Goshen Wind, Inc.

Revision to the Water Assessment and Water Body Report – Goshen Wind Energy Centre

60301207

November, 2013

Figure 2-1

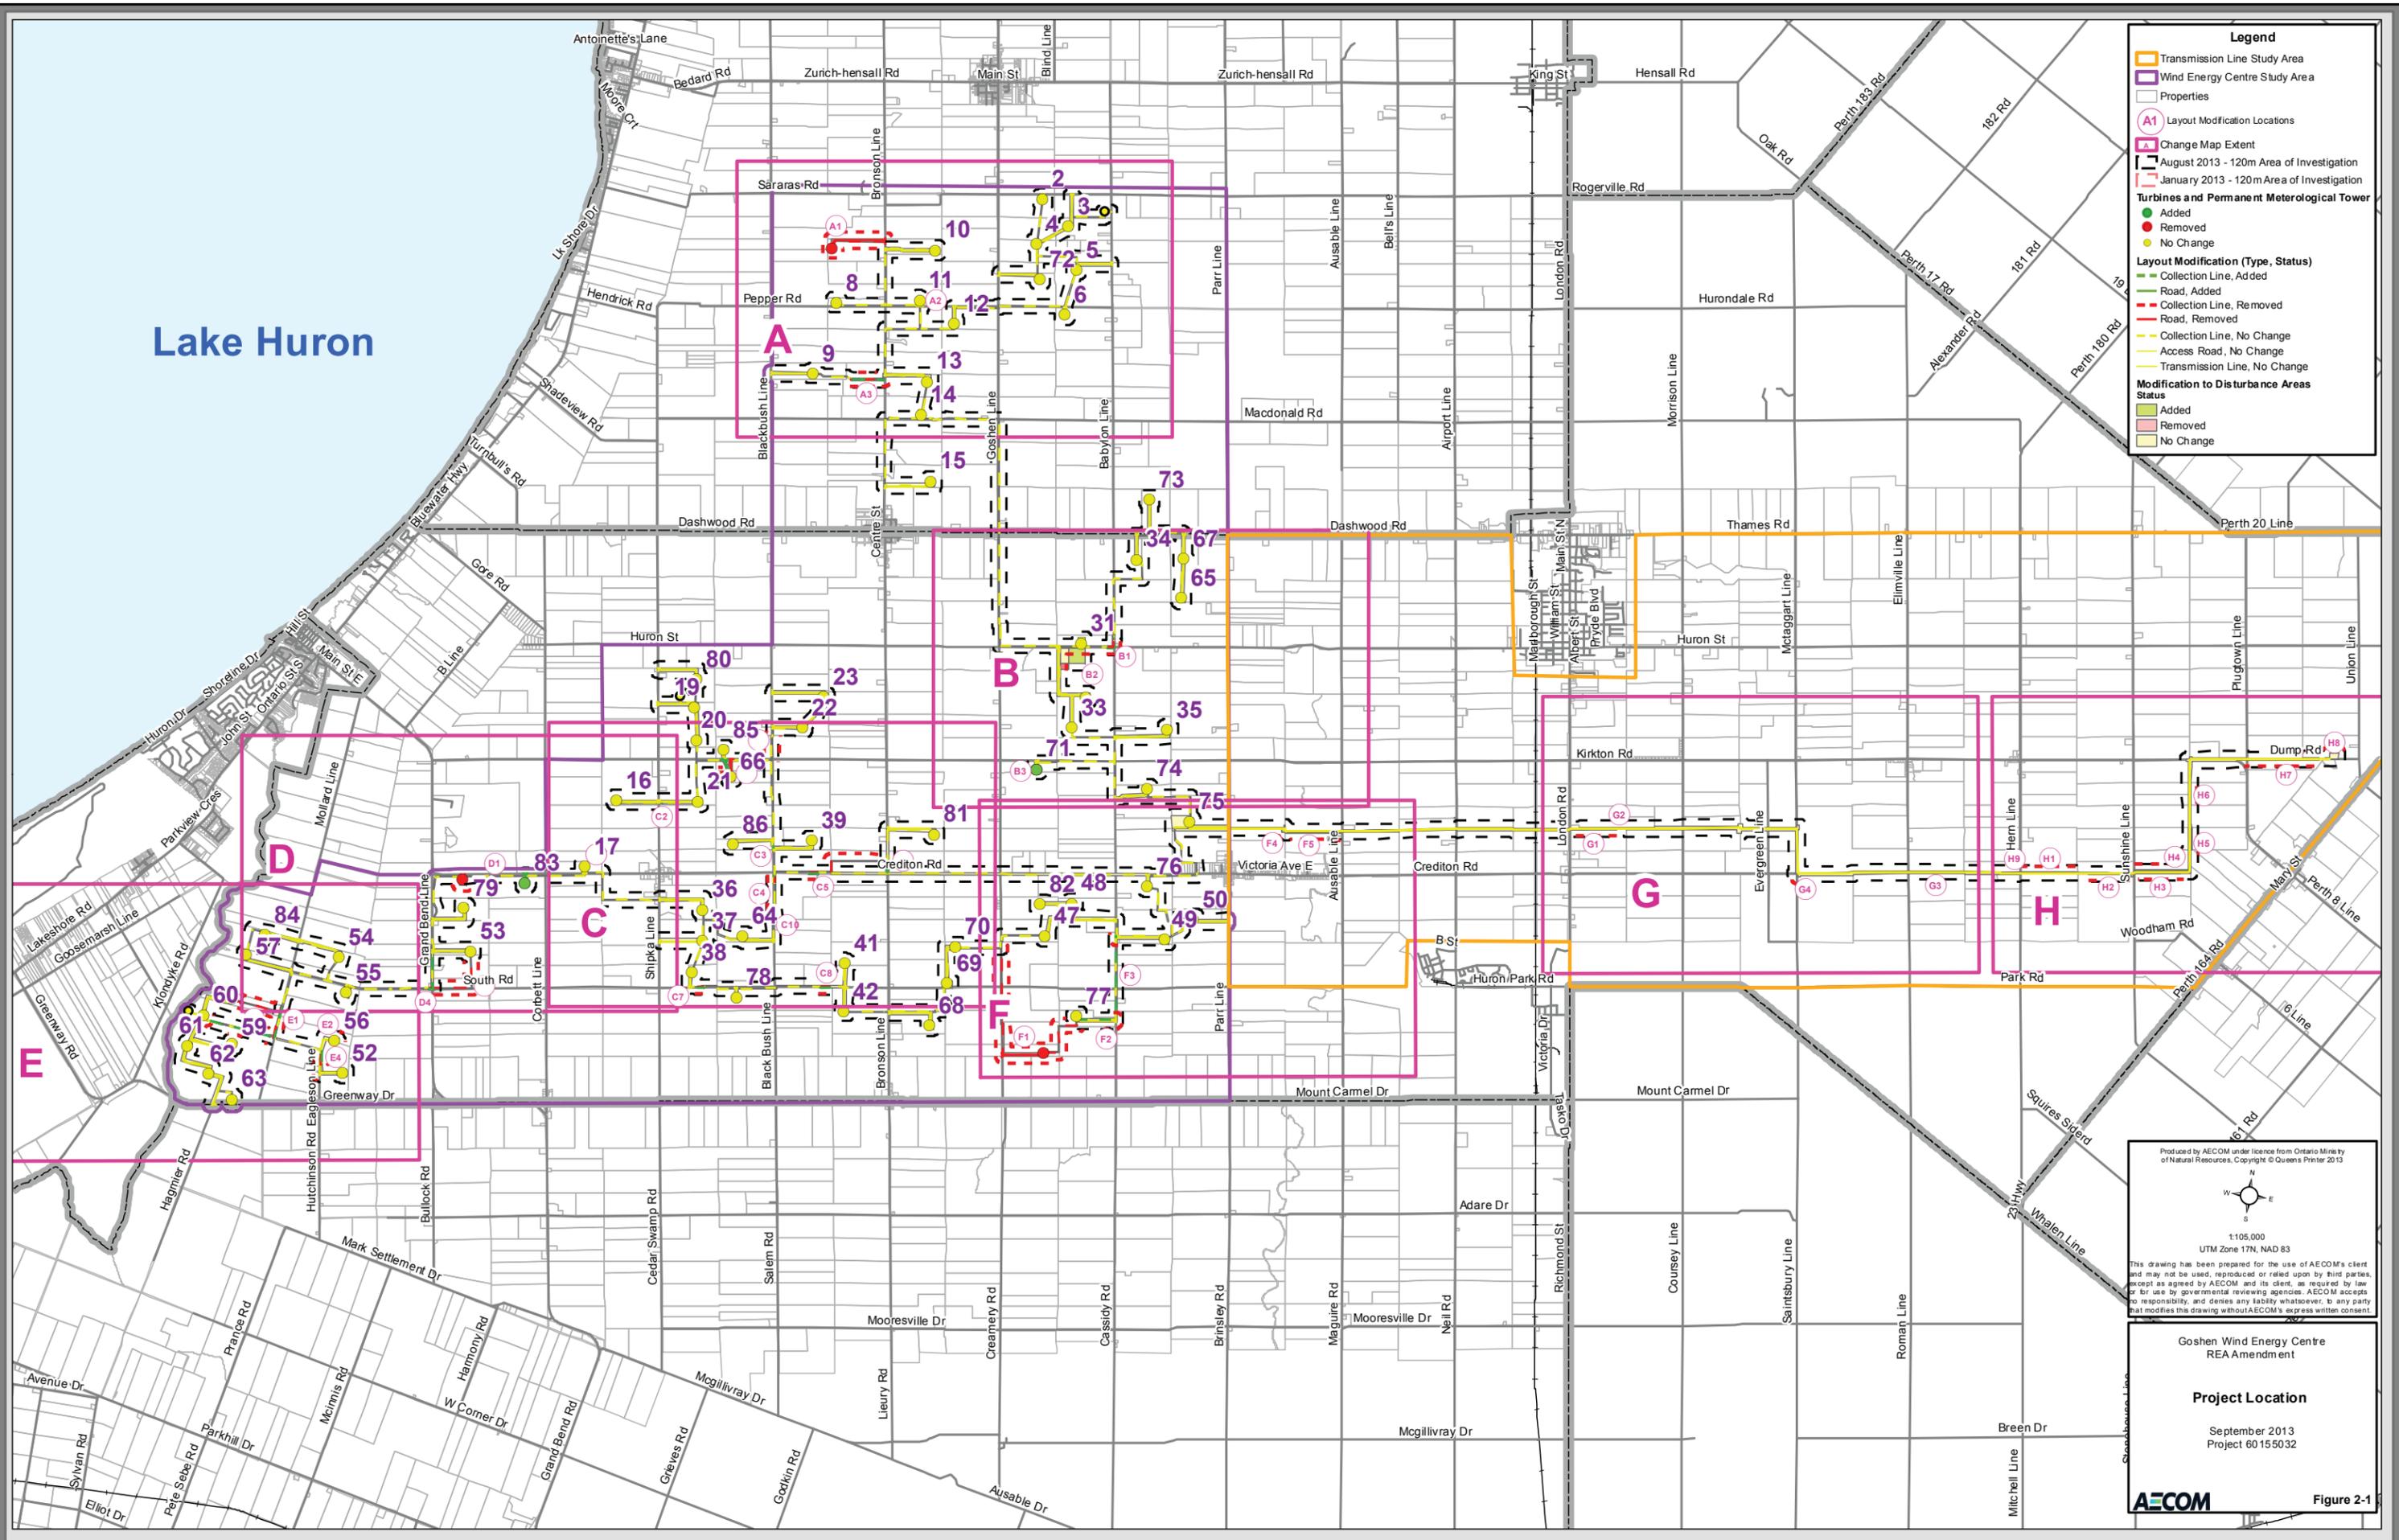
Label on Figure 2-1	Proposed Modification	Rationale for Proposed Modification	New Potential Environmental Effects	New Mitigation Measures (related to Water Bodies) ¹
A1	Removal of Turbine 7 and associated access road and collection line	Turbine and associated infrastructure removed	None – no new water body features within 120 m	N/A
A2	Removal of a portion of Turbine 11 construction disturbance area.	Construction disturbance area modified to reduce or eliminate impacts to Conservation Authority regulation limit	None – no new water body features within 120 m	N/A
A3	Relocation of collection line to Turbine 9 17 m to southern property boundary, west of Bronson Line	Construction disturbance area modified to reduce or eliminate impacts to archaeological resources	None – no new water body features within 120 m	N/A
B1	Relocation of collection line from private property to Babylon Line and Huron Street right-of-way	Construction disturbance area modified to reduce or eliminate impacts to archaeological resources	None – no new water body features within 120 m	N/A

B2	Temporary construction laydown area modified and increased in size	Infrastructure or construction disturbance area added or changed to optimize project design/ constructability	None – no new water body features within 120 m	N/A
B3	Relocation of Turbine 71 15 m north within the existing turbine construction disturbance area	Infrastructure or construction disturbance area added or changed to optimize project design/ constructability	None – no new water body features within 120 m	N/A
C1	Relocation of access road to Turbine 66 to the west	Infrastructure or construction disturbance area added or changed to optimize project design/ constructability	None – no new water body features within 120 m	N/A
C2	Removal of a portion of construction disturbance area, east of Shipka Line, for the access road and collection line to Turbine 21	Construction disturbance area modified to reduce or eliminate impacts to archaeological resources	None – removal of infrastructure	N/A

C3	Addition of collection line construction disturbance area in the Black Bush Line right-of-way, east of Turbine 86	Infrastructure or construction disturbance area added or changed to optimize project design/ constructability	None – no new water body features within 120 m	N/A
C4	Relocation of collection line from private property to Black Bush Line right-of-way in two locations, northeast of Turbine 64	Construction disturbance area modified to reduce or eliminate impacts to archaeological resources	None – no new water body features within 120 m	N/A
C5	Relocation of collection line from private property to Crediton Road right-of-way, south of Turbine 39	Construction disturbance area modified to reduce or eliminate impacts to archaeological resources	None – no new water body features within 120 m	N/A
C6	Relocation of collection line from private property to Bronson Line right-of-way, southwest of Turbine 81	Construction disturbance area modified to reduce or eliminate impacts to archaeological resources	None – no new water body features within 120 m	N/A

C7	Relocation of collection line from private property to South Road right-of-way, southeast of Turbine 38	Construction disturbance area modified to reduce or eliminate impacts to archaeological resources	None – no new water body features within 120 m	N/A
C8	Relocation of collection line from private property to South Road right-of-way, southwest of Turbine 41	Construction disturbance area modified to reduce or eliminate impacts to archaeological resources	None – no new water body features within 120 m	N/A
C9	Realignment of collection line from Black Bush Line right-of-way onto private property west of Black Bush Line	Infrastructure or construction disturbance area added or changed to optimize project design/ constructability	None – no new water body features within 120 m	N/A
C10	Removal of a portion of collection line disturbance area on private property, along Black Bush Line	Infrastructure or construction disturbance area added or changed to optimize project design/ constructability	None – removal of infrastructure	N/A

D1	Relocation of Turbine 83 and associated construction disturbance area 1,140 m to the east	Infrastructure or construction disturbance area added or changed to optimize project design/ constructability	<p>Water Bodies:</p> <ul style="list-style-type: none"> • Effects associated with construction of turbine and associated construction disturbance area within 120 m of water body D05 include: <ul style="list-style-type: none"> - Increase to surface water temperature from reduced groundwater contribution if dewatering activities are required for excavation of turbine foundations - Increase to stream flows in watercourses that receive temporary groundwater dewatering discharge (if required). Groundwater discharge has potential to cause streambed and/or bank erosion and downstream sedimentation if not managed properly. - Increased erosion, sedimentation and turbidity in watercourse from clearing and grubbing for on adjacent lands for construction of turbines, pads and turnaround areas. - Soil compaction, which may result in hardening of surfaces and increased runoff into watercourses. - Release / discharge of runoff from the construction area, which has the potential to transport sediment and nutrients into the watercourse. - Soil/water contamination by oils, grease and other materials from accidental spills and release of contaminants from construction equipment. • Effects associated with new turbine location within 120 m of water body D05 include: <ul style="list-style-type: none"> - Increase in impervious surfaces from presence of turbine foundation and access roads, resulting in increased water temperatures, increased surface runoff and stream peak flows, and reduced infiltration, base flows and upwelling. 	<ul style="list-style-type: none"> • Mitigation measures associated with turbine construction within 120 m of a water body include (refer to Appendix B for detailed mitigation measures under the following headings): <ul style="list-style-type: none"> - Water management - Timing windows - Water quality - Erosion and sediment control - Grading and excavation - Equipment use - Material Stockpiling and handling • Mitigation measures associated with new turbine location within 120 m of a water body include: <ul style="list-style-type: none"> - N/A

Label on Figure 2-1	Proposed Modification	Rationale for Proposed Modification	New Potential Environmental Effects	New Mitigation Measures (related to Water Bodies) ¹
D2	Removal of the southwest portion of Turbine 17 construction disturbance area	Construction disturbance area modified to reduce or eliminate impacts to archaeological resources	None – removal of infrastructure	N/A
D3	Relocation of collection line from private property to Grand Bend Line right-of-way, south and west of Turbine 53	Infrastructure or construction disturbance area added or changed to optimize project design/ constructability	None – no new water body features within 120 m	N/A
D4	Relocation of collection line from private property to South Road right-of-way, east of Turbine 55	Infrastructure or construction disturbance area added or changed to optimize project design/ constructability	None – no new water body features within 120 m	N/A

E1	Relocation of collection line from private property to Mollard Line right-of-way, west of Turbine 56	Construction disturbance area modified to reduce or eliminate impacts to archaeological resources	None – no new water body features within 120 m	N/A
E2	Removal of a portion of Turbine 56 construction disturbance area	Construction disturbance area modified to reduce or eliminate impacts to Conservation Authority regulation limit	None – removal of infrastructure	N/A
E3	Addition of collection line construction disturbance area on private property, heading west to Turbine 60 from Mollard Line, and removal of collection line heading west to Turbine 58 from Mollard Line	Construction disturbance area modified to reduce or eliminate impacts to archaeological resources	None – no new water body features within 120 m	N/A
E4	Addition of construction disturbance area for access road and collection line to Turbine 56 from Eagleson Line	Infrastructure or construction disturbance area added or changed to optimize project design/ constructability	None – no new water body features within 120 m	N/A

F1	Removal of Turbine 46 and associated access road and collection line, including collection line in the Gordon Line right-of-way and collection line on private property to Turbine 77	Turbine and associated infrastructure removed	None – removal of infrastructure	N/A
F2	Removal of a portion of construction disturbance area for access road and collection line to Turbine 77	Construction disturbance area modified to reduce or eliminate impacts to archaeological resources	None – removal of infrastructure	N/A
F3	Addition of collection line in Babylon Line right-of-way, between the access road to Turbine 77 and the access road to Turbine 49	Infrastructure or construction disturbance area added or changed to optimize project design/ constructability	<ul style="list-style-type: none"> • New effects associated with collection line crossing water body D15 include: <ul style="list-style-type: none"> - Soil / water contamination by oils, gasoline, grease and other materials from accidental spills and release of contaminants from equipment. - Release / discharge of runoff from the construction area, which has the potential to transport sediment and nutrients into the watercourse 	<ul style="list-style-type: none"> • Mitigation measures associated with turbine construction within 120 m of a water body include (refer to Appendix B for detailed mitigation measures under the following headings): <ul style="list-style-type: none"> - Directional Drilling - Water Quality - Equipment use - Erosion and sediment control

F4	Addition of transmission line construction disturbance area on private property, west of Parr Line	Infrastructure or construction disturbance area added or changed to optimize project design/ constructability	None – no new water body features within 120 m	N/A
F5	Removal of a portion of transmission line construction disturbance area on private property, west of Ausable Line and relocation of transmission line to an overhead position crossing the Ausable River.	Infrastructure or construction disturbance area added or changed to optimize project design/ constructability	None – removal of infrastructure	N/A
G1	Addition of transmission line construction disturbance area on private property, west of London Road	Infrastructure or construction disturbance area added or changed to optimize project design/ constructability	None – no new water body features within 120 m	N/A
G2	Addition of transmission line construction disturbance area on private property, west of London Road	Infrastructure or construction disturbance area added or changed to optimize project design/ constructability	None – no new water body features within 120 m	N/A

G3	Addition of transmission line construction disturbance area in the Crediton Road right-of-way	Infrastructure or construction disturbance area added or changed to optimize project design/ constructability	None – no new water body features within 120 m	N/A
G4	Removal of a portion of transmission line construction disturbance area on private property, south of Crediton Road and east of McTaggart Line	Infrastructure or construction disturbance area added or changed to optimize project design/ constructability	None – removal of infrastructure	N/A
H1	Addition of transmission line construction disturbance area on private property, east of Hern Line	Infrastructure or construction disturbance area added or changed to optimize project design/ constructability	None – no new water body features within 120 m	N/A
H2	Addition of transmission line construction disturbance area on private property, west of Sunshine Line	Infrastructure or construction disturbance area added or changed to optimize project design/ constructability	None – no new water body features within 120 m	N/A

H3	Addition of transmission line construction disturbance area on private property, east of Sunshine Line	Infrastructure or construction disturbance area added or changed to optimize project design/ constructability	None – no new water body features within 120 m	N/A
H4	Removal of a portion of transmission line construction disturbance area on private property, east of Sunshine Line	Infrastructure or construction disturbance area added or changed to optimize project design/ constructability	None – removal of infrastructure	N/A
H5	Addition of transmission line construction disturbance area on private property, south of Dump Road and west of Sunshine Line,	Infrastructure or construction disturbance area added or changed to optimize project design/ constructability	None – no new water body features within 120 m	N/A

Label on Figure 2-1	Proposed Modification	Rationale for Proposed Modification	New Potential Environmental Effects	New Mitigation Measures (related to Water Bodies)¹
H6	Addition of transmission line construction disturbance area on private property, south of Dump Road and west of Sunshine Line	Infrastructure or construction disturbance area added or changed to optimize project design/ constructability	None – no new water body features within 120 m	N/A
H7	Addition of transmission line construction disturbance area on private property, on the south side of Dump Road, east of Plugtown Line	Infrastructure or construction disturbance area added or changed to optimize project design/ constructability	None – no new water body features within 120 m	N/A
H8	Addition of transmission line construction disturbance area on private property, on the north side of Dump Road, west of Union Line and addition and removal of portions of the transmission line point of interconnect construction disturbance area	Infrastructure or construction disturbance area added or changed to optimize project design/ constructability	None – no new water body features within 120 m	N/A

H9	Removal of a portion of transmission line construction disturbance area on private property, north of Crediton Road, and west of Hern Line	Construction disturbance area modified to reduce or eliminate impacts to archaeological resources	None – removal of infrastructure	N/A
N/A	Use of a spare 170 mVA transformer to be stored within the existing footprint of the Jericho Wind Energy Centre substation.	Infrastructure or construction disturbance area added or changed to optimize project design/ constructability	N/A	N/A
